RE: Huntington BRO 1445 (35)
Bridge 30 Replacement on Camel's Hump Road (TH 22) over Brush Brook
Contractor Erosion Prevention & Sediment Control Plan

Contractor EPSCP Modifications 2016.04.05
by M.Montgomery of VT Compliance

PROJECT NAME: HUNTINGTON	
PROJECT NUMBER: BRO 1445(35)	
FILE NAME: sl2j162bdrero.dgn	PLOT DATE: 15-OCT-2015
PROJECT LEADER: C. CARLSON	DRAWN BY: R. PELLETT
DESIGNED BY: C. MOONEY	CHECKED BY: D. PETERSON
EPSC EXISTING CONDITIONS	SHEET 38 OF 44

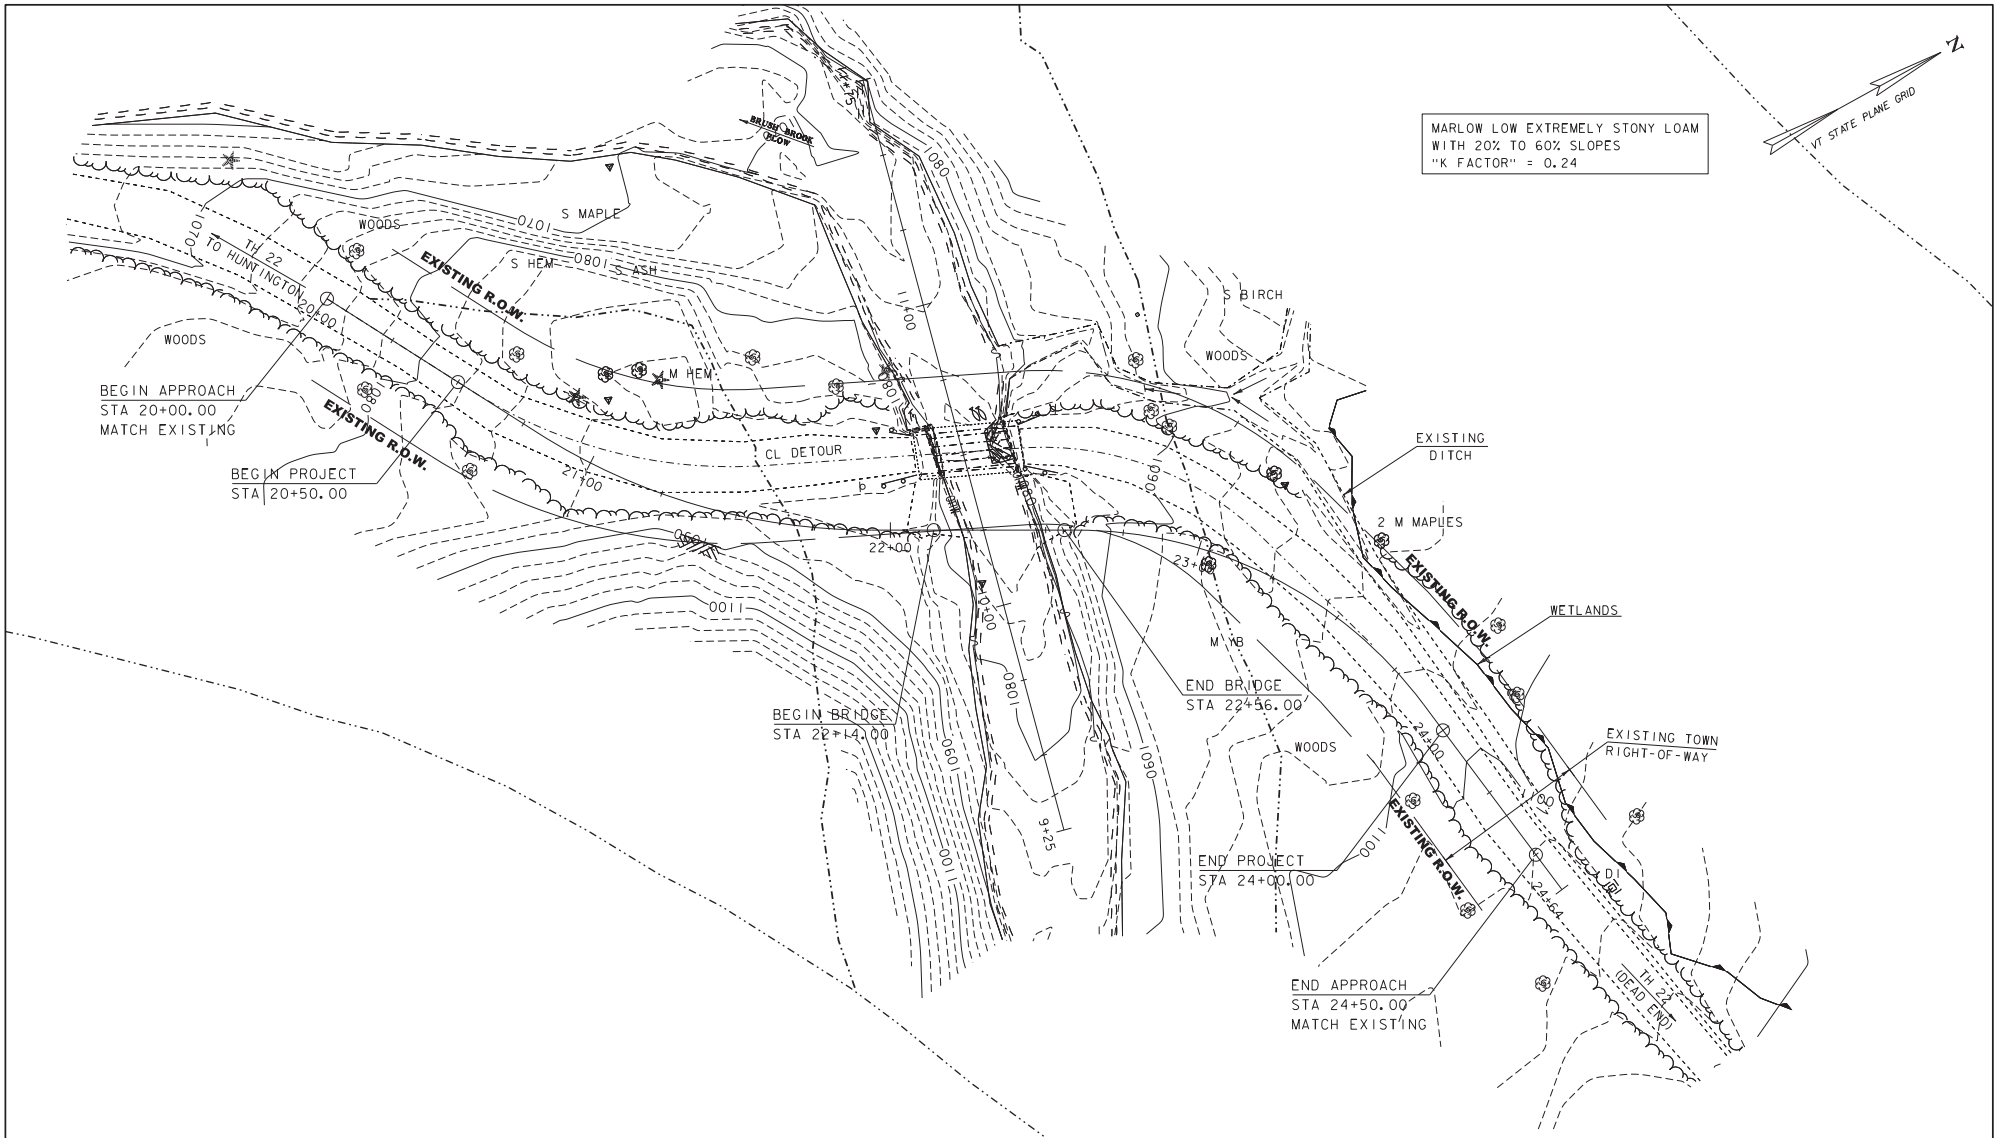
There are no substantial changes to specific EPSC measures other than the in-stream measures to isolate flows from the river work. The attached plan sheets were modified from what was included in the contract plan set (sheets 37-40 of the original 44 sheets) to illustrate specific measures discussed in section 1.4 above.

- Instead of a floating sediment barrier, channel excavations will be isolated from surface water flow with four-sided cofferdams formed with steel sheet pilings.
- Temporary sandbags and poly sheeting may be used to isolate sheet piling installation from surface waters pending coordination with VT DEC District River's Engineer.
- Vehicle tracking pads will be installed at the discretion of the OSPC.
- Potential locations of dewatering areas have been identified.
- Parent's 'On-Site Coordinator' contact information has been added.

SILT FENCE

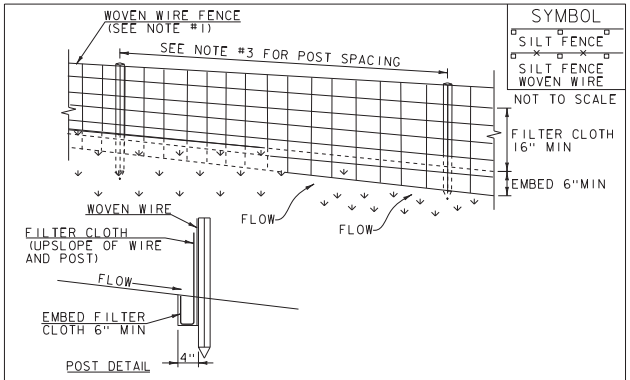
THIS WORK SHALL BE PERFORMED IN ACCORDANCE WITH SECTION 649 AND AS SHOWN IN THE PLANS FOR GEOTEXTILE FOR SILT FENCE (PAY ITEM 649.51) ~~OR GEOTEXTILE FOR SILT FENCE, WOVEN WIRE REINFORCED (PAY ITEM 649.515).~~

STABILIZED CONSTRUCTION ENTRANCE

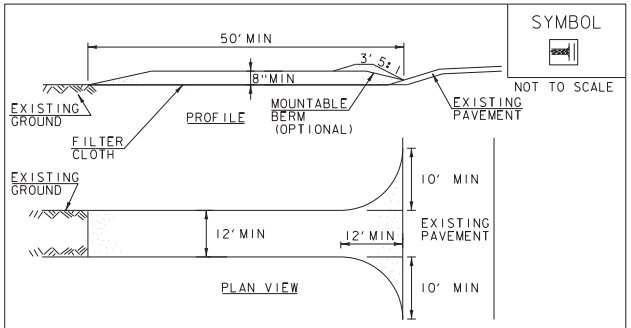
Tracking pads are specified in the contract EPSCP. These are intended to limit sediment tracking outside the project area and onto public highways. This is an appropriate BMP when a construction project is accessed via paved roads. On this project, which is found on a Class 3 road, the measure would be unlikely to decrease road-derived sediment loading to surface waters. I recommend that stabilized construction entrances/exits be installed only if determined necessary by the OSPC and RE after evaluating site conditions during the construction operations.

~~THIS WORK SHALL BE PERFORMED IN ACCORDANCE WITH SECTION 653 FOR VEHICLE TRACKING PAD (PAY ITEM 653.35) OR AS SPECIFIED IN THE CONTRACT.~~

ROLLED EROSION CONTROL PRODUCT (RECP) SIDE SLOPE

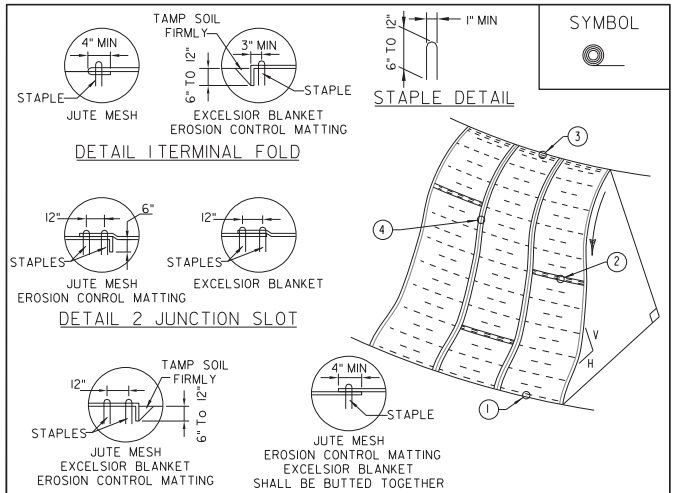
THIS ITEM SHALL BE PAID FOR UNDER ITEM 653.20 TEMPORARY EROSION MATTING ~~OR 653.21 PERMANENT EROSION MATTING~~

FILTER BAG

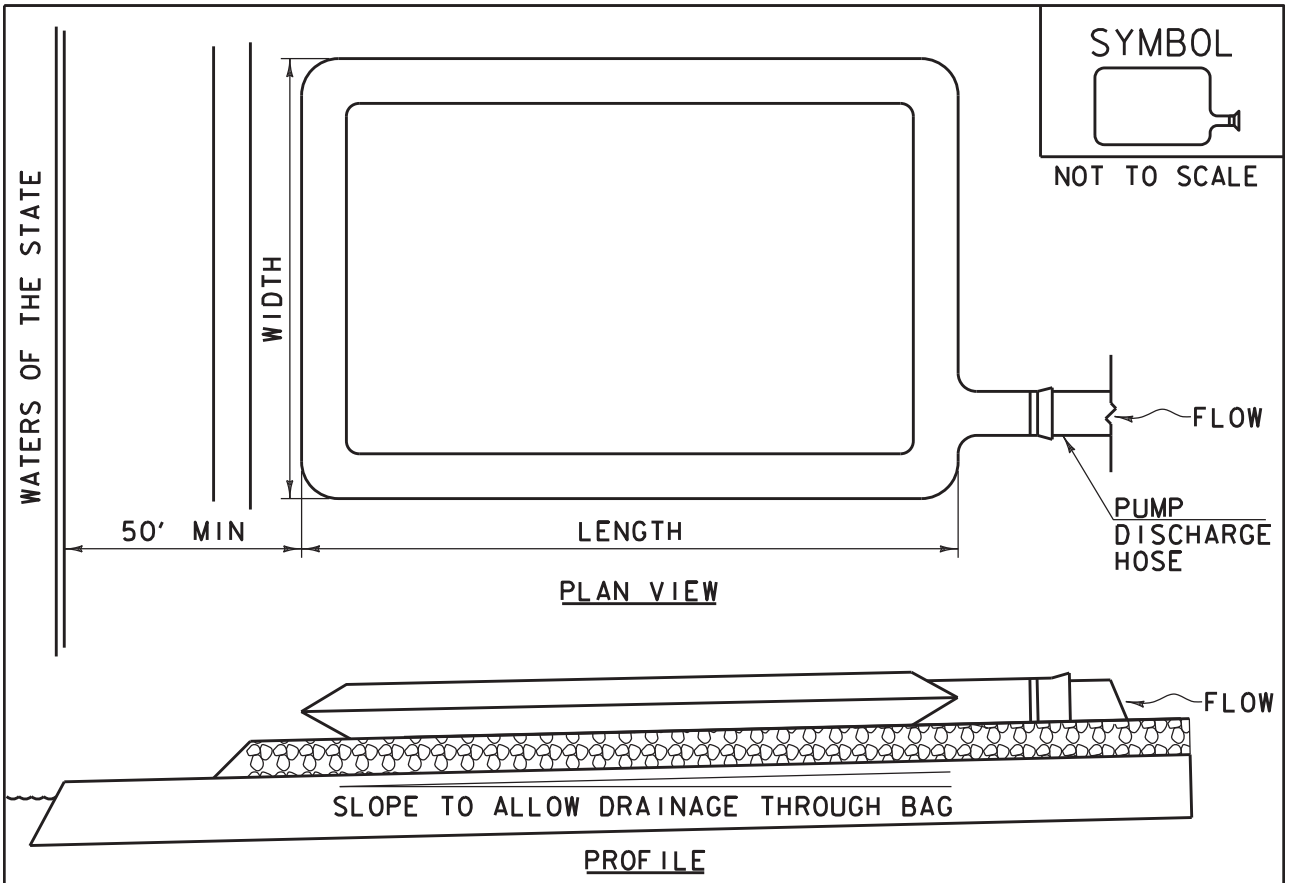
Water pumped from the cofferdams will be directed into non-woven geotextile filter bags (detail sheet attached). Filter bags will be located so filtered discharge will not cause erosion. Extra bags will be kept on-site and available to replace clogged or damaged bags as required to maintain flow capacity and treatment. Sediments trapped by filter bags will be disposed of off-site as earthen waste. Bags may be situated on a bed of crushed (1" minus) filter stone to increase filtration efficiency. Additional measures such as wood chips, stone berms, hay bales, or plastic sheeting may be used to better capture suspended sediments in the pump out or to stabilize the outfall area.
